**SUBJECT: NEW VEHICLE DEMONSTRATION / DELIVERY HOLD**

**Update Prior to Sale 21U06**

Certain 2021 Explorer Vehicles Equipped with 2.3L Engines

Inspect Left Hand Engine Mount

**FIGURE 1**

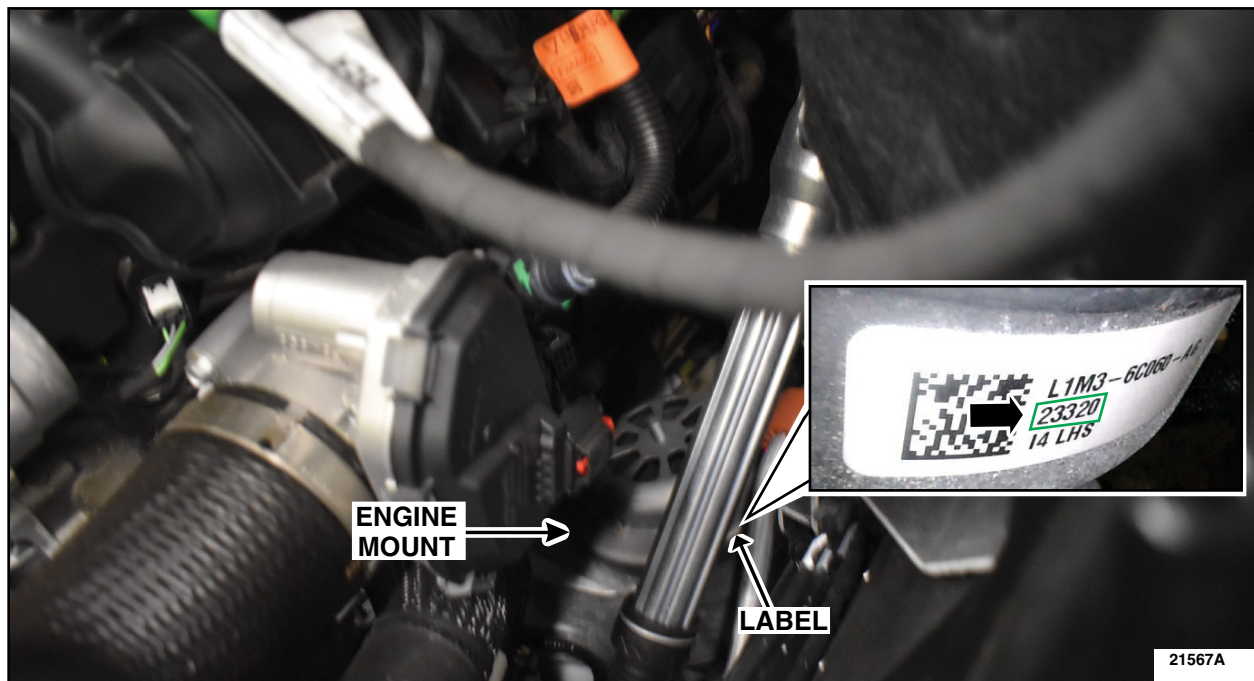
1. Read the date code from the Left Hand (LH) engine mount.
2. Is the date code 25621? See Figure 1.

**NO** - Date code inspection **PASSES**. Program is Complete.

**YES** - Date code inspection **FAILS**. Proceed to Step 3.

3. Replace the suspect LH engine mount. Please follow the Workshop Manual (WSM) procedures in Section 303-01A.
4. Check and correct front toe alignment. Please follow the WSM procedures in Section 204-00.
